15.7 Radioactive Release from Subsystems and Components

The information in this section of the reference ABWR DCD, including all subsections, figures and tables, is incorporated by reference with the following departure and supplements.

STD DEP 11.3-1 (Figure 15.7-2)

Figure 15.7-2 Offgas System (See Subsection 11.3)

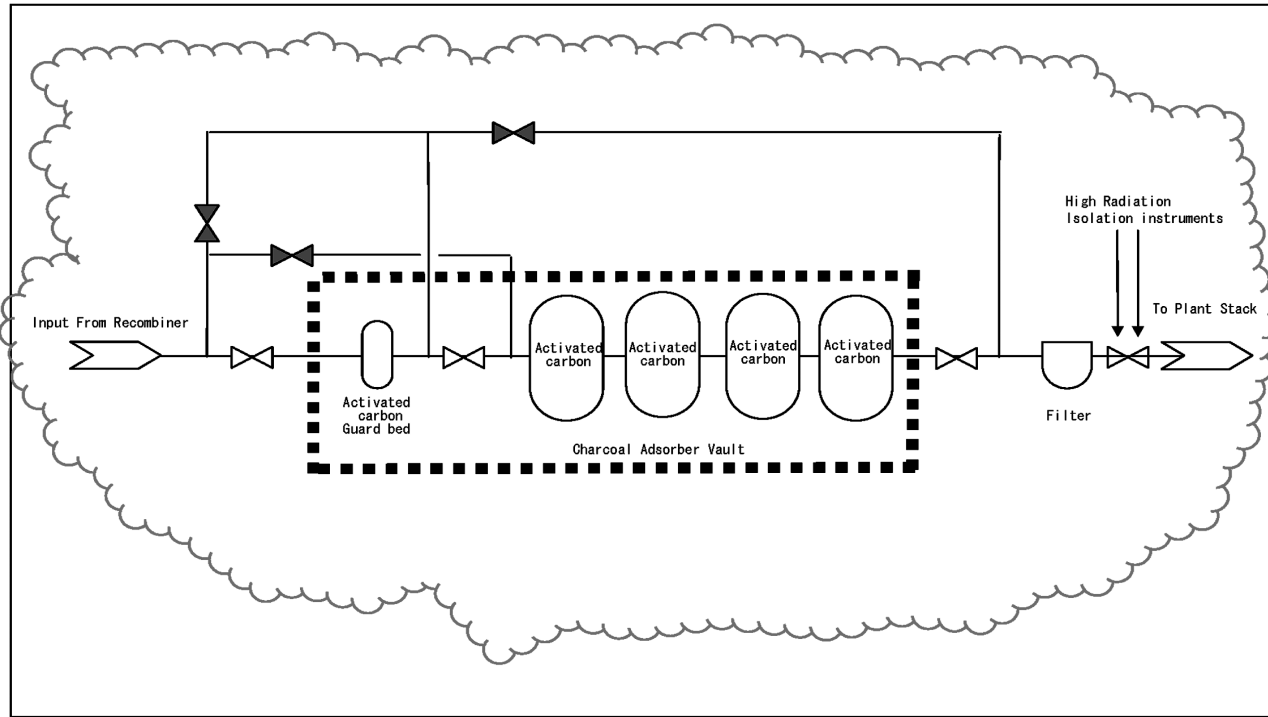
To evaluate the potential radiological consequences of an inadvertent bypass of the charcoal beds, it was assumed that operator error or computer error has led to the bypass of the ~~eight~~four follow-on beds in addition to the failure of the automated air operated downstream isolation valve. It is also assumed that during this period, the plant is running at and continues to run at the maximum permissible offgas rate of 14.8 GBq/s (based upon the assumption of 0.0037 GBq/s/MWt as stipulated in Standard Review Plan 11.3) evaluated to a decay time of 30 minutes from the vessel exit nozzle. Even with the failure of the downstream isolation valve, it is not anticipated or assumed that the isolation instrumentation would fail but would instead

- (1) Flow is through a single 4,721 kg charcoal tank with an evaluated hold up time given by NUREG-0016, equation 1.5.1.6 using K_d 's for Kr and Xe from NUREG-0016.
- (2) ~~An isolation valve prevents flow through the~~ ~~There is no motive force to~~ ~~remove any significant inventory from the eight~~ follow-on charcoal tanks while in bypass and therefore no activity from these tanks is included in the final release calculations.
